NORTH ANNA POWER STATION, UNIT NO. 2

AMENDMENT TO FACILITY OPERATING LICENSE

Amendment No. 64  
License No. NPF-7

ATTACHMENT TO LICENSE AMENDMENT NO. 64

Figure 3.2-2  $K(Z)$  - Normalized  $F_Q(Z)$  as a Function of Core Height

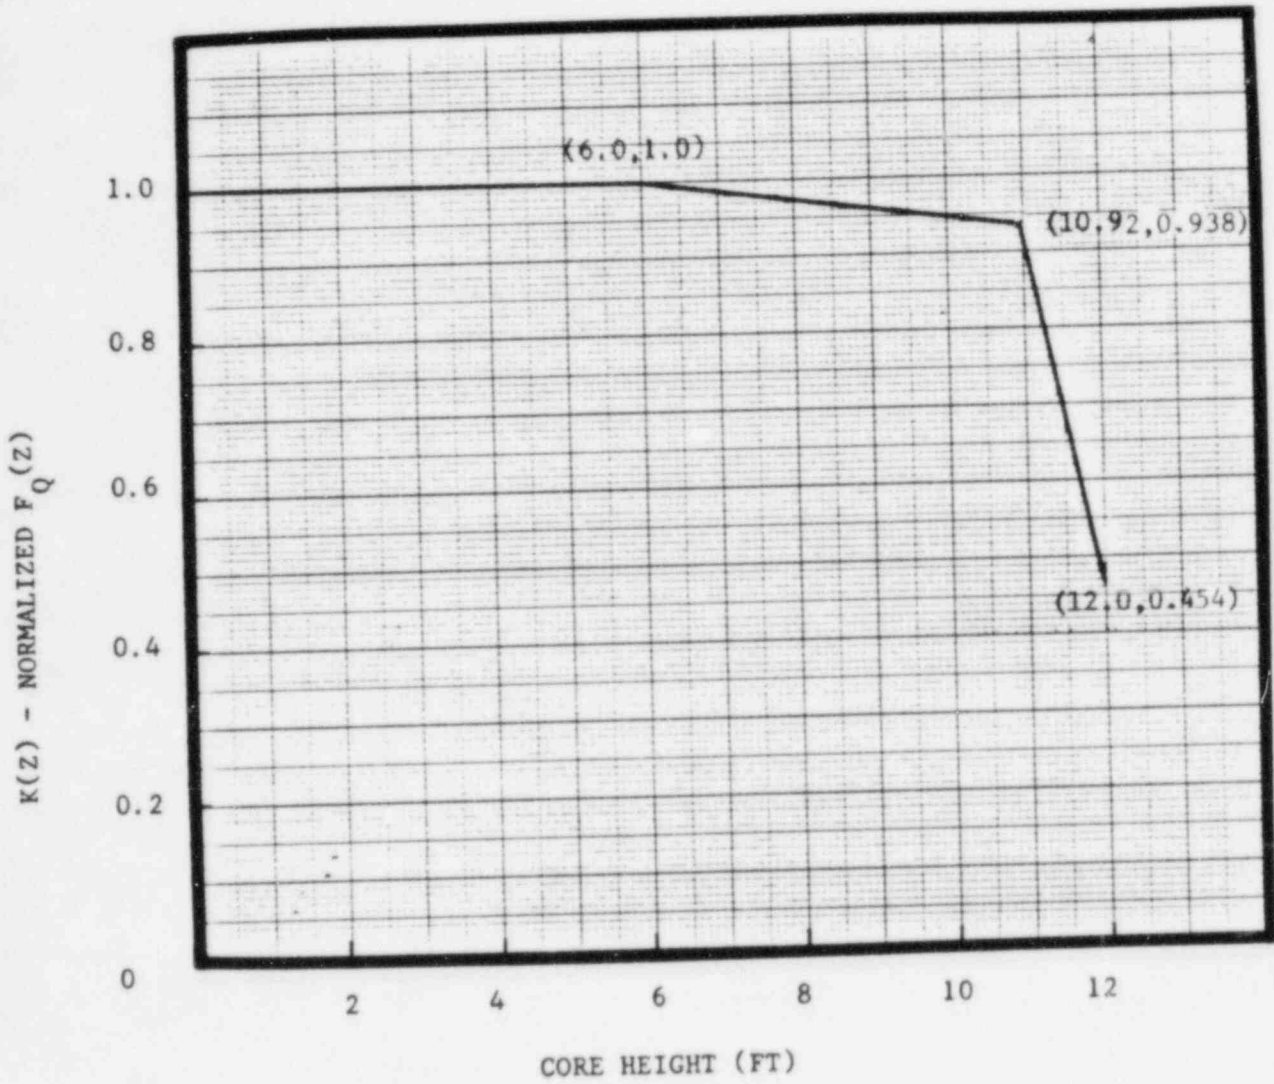
and  $K(Z)$  is the function obtained from Figure 3.2-2 for a given core height location.

where  $F_Q^M(z)$  is the measured  $F_Q(z)$  increased by the allowances for manufacturing tolerances and measurement uncertainty, 2.20 is the  $F_Q$  limit,  $K(z)$  is given in Figure 3.2-2,  $P$  is the relative THERMAL POWER, and  $N(z)$  is the cycle dependent function that accounts for power distribution transients encountered during normal operation. This function is given in the Core Surveillance Report as per Specification 6.9.1.7.
